NOTICE OF DECISION

**CONDITIONAL USE / PARTITION TENTATIVE PLAN / CLASS 3 SITE PLAN
REVIEW / CLASS 2 ADJUSTMENT CASE NO.: CU-PAR-SPR-ADJ25-03**

SUMMARY: Development of a new drive-through oil change business.

LOCATION: 3271 Lancaster Dr NE, Salem OR 97305

① TENTATIVE PARTITION PLAN
1" = 20'-0"

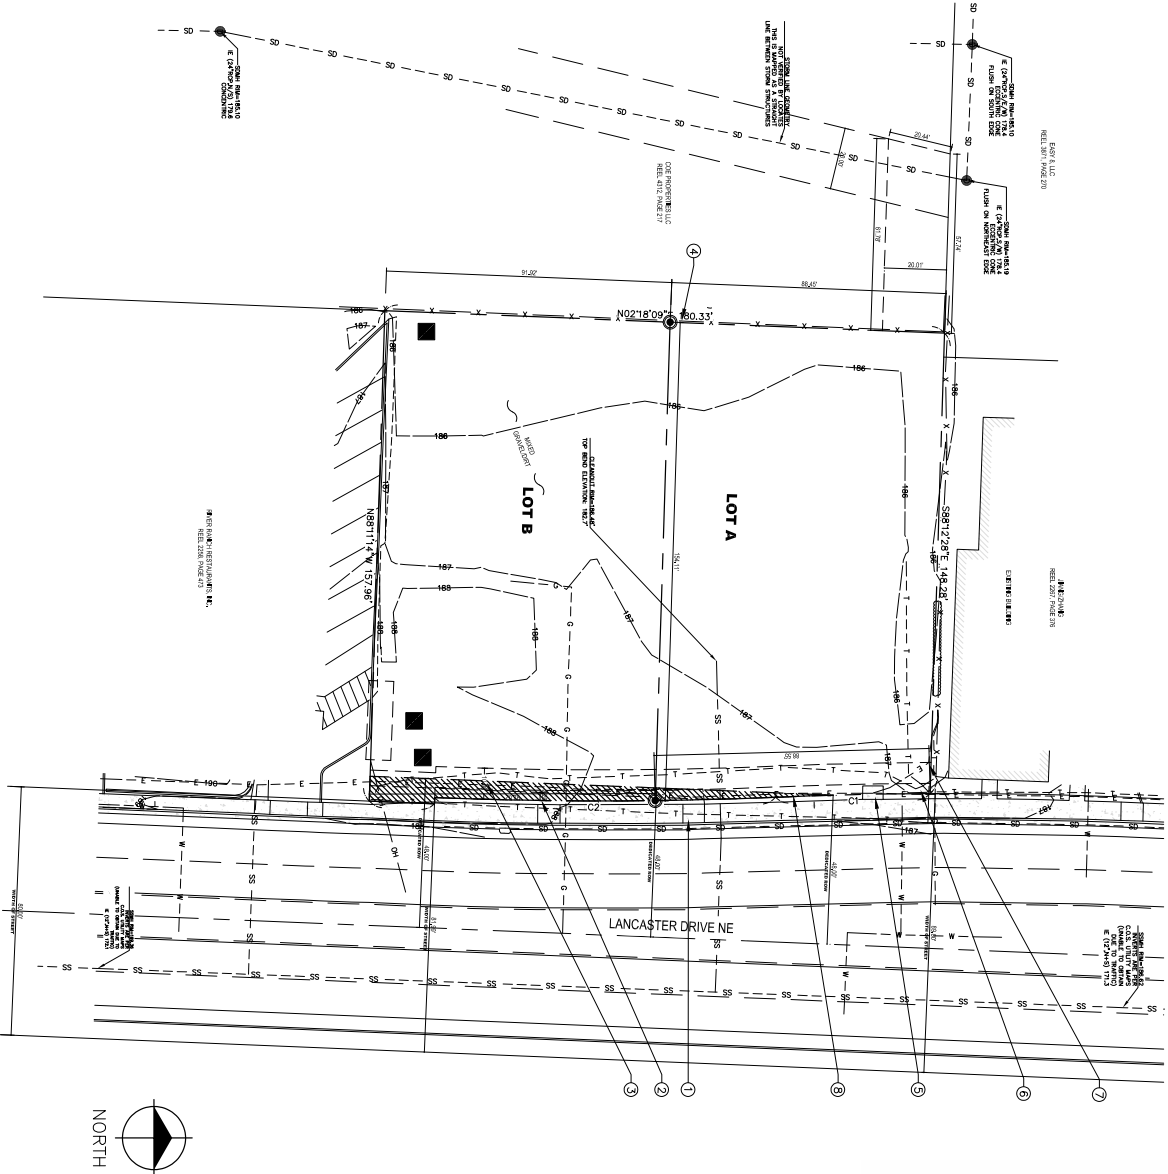
Finding 7. SRC 200.050(d) requires that right-of-way dedicated to the City be free of encumbrances and liens. Right-of-way dedication is required along Lancaster Drive NE. There is an existing electrical vault, electrical transformer, and communication riser along Lancaster Drive NE. It is unclear whether these power facilities are located in an existing easement on the subject property. As a condition of approval, the applicant shall ensure required right-of-way is unencumbered, obtain quitclaims from private utility owners where there are conflicts, or receive an adjustment to this standard per SRC 200.050(d).

Finding 14: Landcaster Drive NE is a major arterial. SRC 804.035(a) provides that driveway approaches onto arterial streets are permitted where they provide shared access between two or more abutting properties. The applicant's tentative partition plan indicates that the existing driveway

approach to Lancaster Drive NE will be shared between proposed Parcels 1 and 2. Prior to final plat approval, the applicant shall provide a shared access easement between Parcels 1 and 2 for the driveway approach to Lancaster Drive NE.

Finding 18: The subject property is approximately 0.64–acres in size and is currently vacant. Abutting land to the north, south and west is fully developed. The proposed partition results in the creation of two parcels that will utilize an existing shared driveway approach to Lancaster Drive NE to provide vehicular access to each parcel. The tentative partition does not impede access to abutting land.

- Condition 6:** On the final plat, convey land for dedication to equal a half-width right-of-way of 48-feet on the development side of Lancaster Drive NE.

- Condition 7:** On the final plat, provide a 10-foot-wide public utility easement along the frontage of Lancaster Drive NE on the final plat.
- Condition 8:** On the final plat, provide a shared access easement between Parcels 1 and 2 for the driveway approach to Lancaster Drive NE.

Condition 4: Prior to final plat approval, required right-of-way dedications and required easements shall be free and clear of encumbrances and liens unless an adjustment to SRC 200.050(d) is approved

Condition 8: On the final plat, provide a shared access easement between Parcels 1 and 2 for the driveway approach to Lancaster Drive NE.
